Re: Bellewood Drain, Glen Oaks Arm

Re: Bellewood Drain: Glen Oaks

## Map Correction-Field Verification

# "AS-BUILT" RECORD DRAWING **BELLEWOOD DRAIN, GLEN OAKS ARM**

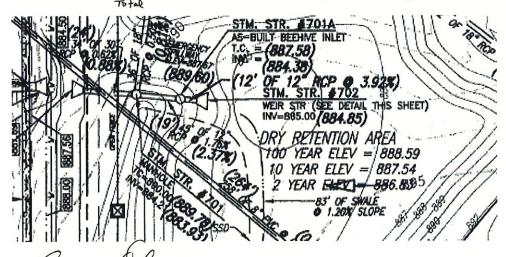
Notes & Sketch: Str. 701A to 701 was incorrectly reported. This drain segment consists of 19' of 12" RCP. Also the 12" RCP was incorrectly tallied on the final report -The correct total of 12" RCP is now 1555 feet. The 18" RCP was incorrect as well. It should be 1519 feet. The 30" RCP is now 61 feet – as the above mentioned segment was reported as 30" RCP.

New Length: 13,570

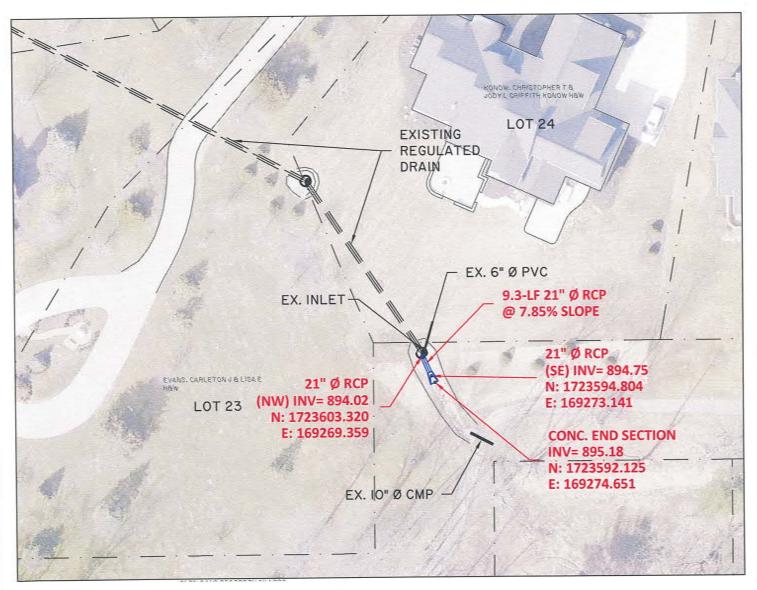
A 15" Stub pipe was removed from existing inlet structure #746 and 9 feet of 21" RCP was placed upstream of the inlet. Also added onto the 21" RCP was a concrete endsection with animal guard.
